FINAL SAFETY EVALUATION REPORT

TRANSNUCLEAR, INC.

STANDARDIZED NUHOMS® HORIZONTAL MODULAR STORAGE

AMENDMENT NO. 11

Figure 5.1. FLUENT Model of NUHOMS® OS197L TC System with Supplemental Shielding

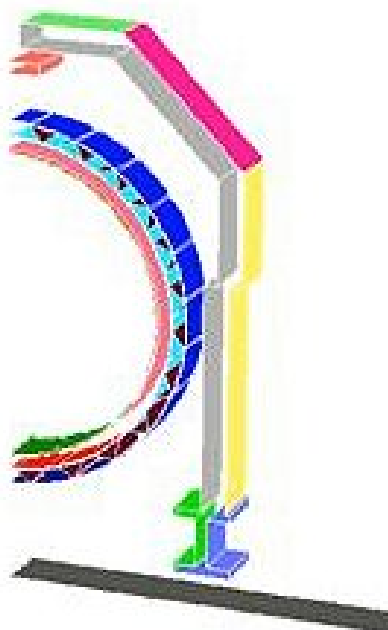
The staff's CFD analysis was performed for ambient conditions of 100°F and 24 kW of total decay heat, based on the decay heat evaluated by the applicant in earlier revisions of their SAR. The applicant later reduced the allowable decay heat load in the OS 197L TC to 13kW. A three-dimensional (3-D) FLUENT CFD model was prepared to represent a 12-inch section of the cask and the transfer skid. The representative transfer cask includes the DSC outer shell, the TC cask rails, the TC cask structural shell, and the liquid water neutron shield. Within the TC, the DSC sits on top of two cask rails, which are located 18.5° from vertical downward below the DSC. The thickness of the cask rails is assumed to be 0.12 inches. The air gap between the DSC shell and the transfer cask structural shell at the bottom closes from 0.405 inches to 0.105 inches. This air gap is also included in the analysis. A uniform 0.01-inch air gap between the cask structural shell and the neutron shield inner skin is modeled as well. The heat load of the fuel assemblies is applied as a uniform heat flux over the inner surface of the DSC shell. All material properties, including liquid water, are obtained from the applicant's SAR.

Three modes of heat transfer are included in the analysis including conduction, natural convection, and radiation. Radiation heat transfer is based on the Discrete Ordinates (DO) method. The staff performed the CFD analysis for normal conditions of transfer and obtained temperatures and a temperature distribution which are generally consistent with the trends found in the applicant's results. Therefore, based on the CFD analysis, the staff concludes that the applicant's approach to represent the heat transfer through the OS197L transfer cask is acceptable.

Figure 5-3 Peak Component Temperatures for 32PT DSC in OS197L TC: Off-Normal Conditions of Transfer (117°F ambient)

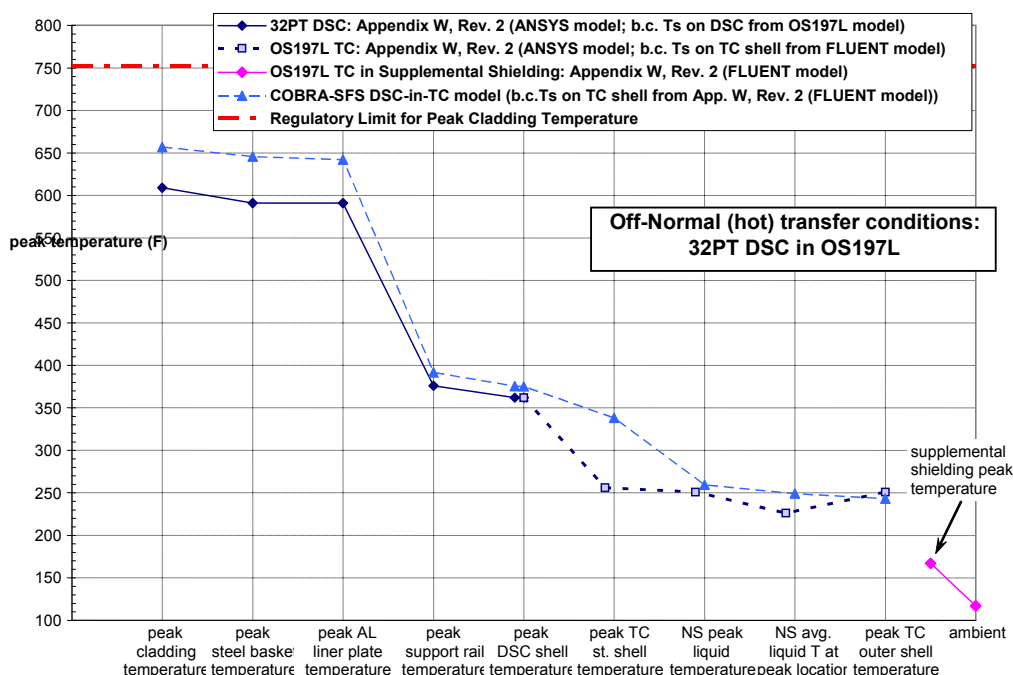
As indicated in Figure 5.3 above, the non-conservative results obtained with the SAR model compared to the confirmatory calculations can be further illustrated by comparison with results reported in Appendix M, for the 32PT within the original (heavier) OS197. Figure 5-6 shows the results for the 32PT using the DSC shell temperatures reported in Appendix M. As with the comparison for Appendix W (shown in Figure 5-5), the confirmatory calculation results are more conservative than those obtained with the ANSYS model documented in Appendix M. The peak cladding temperature predicted in the confirmatory calculations is approximately 24°F higher than the value obtained with the ANSYS model and reported in the SAR. However, for the 32PT DSC within the OS197, which does not require supplemental shielding, the peak cladding temperature obtained in the confirmatory calculations is 13°F below the temperature limit, and therefore the results obtained with the methodology documented in Appendix M were deemed acceptable.

For application to the analysis of the 32PT within the OS197L as presented in Appendix W, however, the non-conservatism of the methodology from Appendix M with respect to the confirmatory calculations is unacceptable, because the peak cladding temperatures are predicted to be much closer to the limit. The results obtained in the confirmatory calculations

predict peak cladding temperatures that are above the regulatory limit for normal and off-normal

Figure 5-4 Peak Component Temperatures for 32PT DSC in OS197L TC: Normal Conditions of Transfer (100°F ambient)

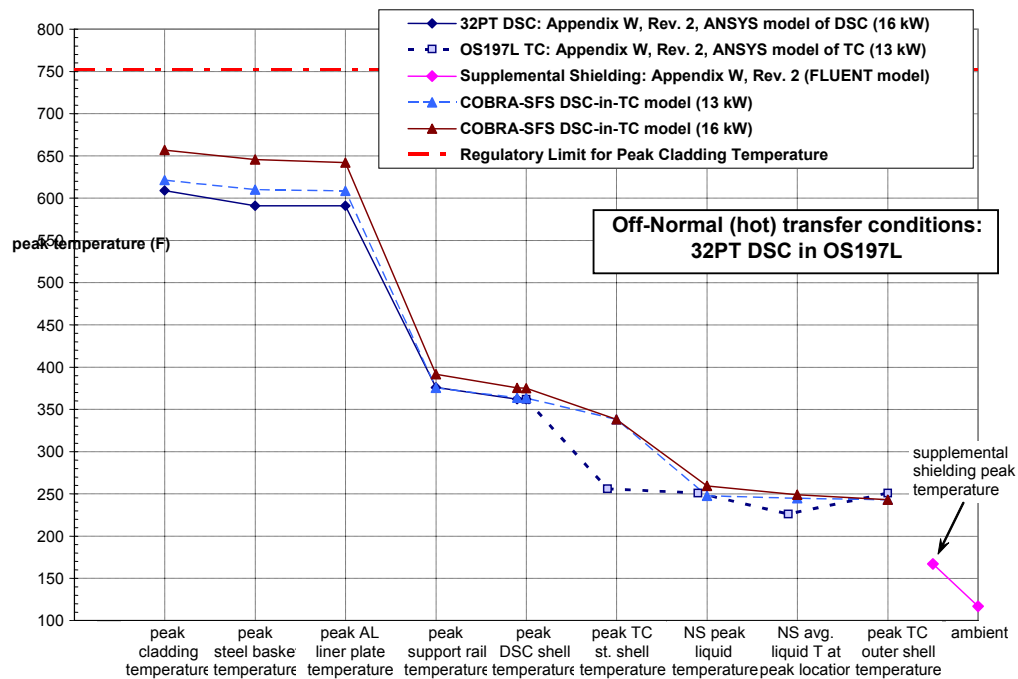
The temperature profile comparisons in Figures 5-3 and 5-4 show very good agreement in the results obtained for the OS197L transfer cask, and the peak DSC shell temperatures differ by

only about 16°F. The peak temperatures predicted for the aluminum support rails differ by approximately the same amount, with the confirmatory calculation results the more conservative of the two. (This is also in contrast to the results for the DSC model shown in Section 4.5.4, in which the SAR model results are more conservative than the confirmatory calculations.) Figure 5-5 shows this conclusively, with confirmatory calculation results with a COBRA-SFS model of the DSC only compared to Appendix W results for the detailed DSC model. In this comparison, both calculations use the same boundary temperatures on the DSC outer shell.

Figure 5-7 Peak Component Temperatures for 32PT DSC within OS197 TC, with and without supplemental shielding: Off-Normal Conditions (117°F ambient)

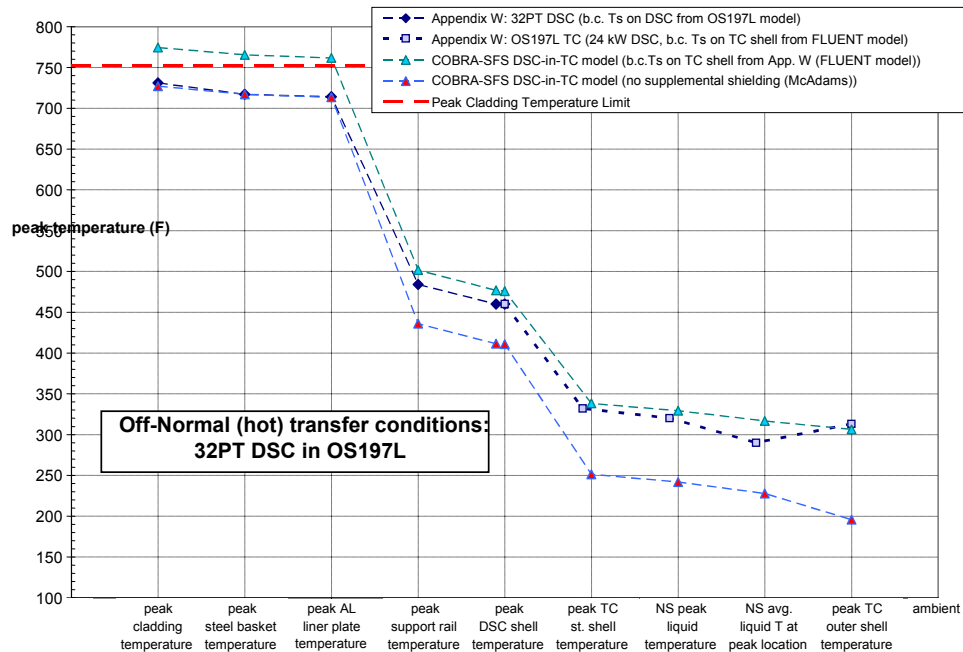
The results obtained for this case are compared to the SAR Appendix W results in Figure 5-7. The confirmatory calculations indicate that without the supplemental shielding, the peak temperature on the OS197L external surface would be more than 100°F lower than the value predicted in the SAR Appendix W with the FLUENT model. As a result, the peak cladding temperature in the confirmatory calculation is only about 727°F, which is 4°F below the value predicted with the SAR methodology *with* the supplemental shielding in place. This further illustrates the non-conservatism of the detailed DSC model in the SAR.
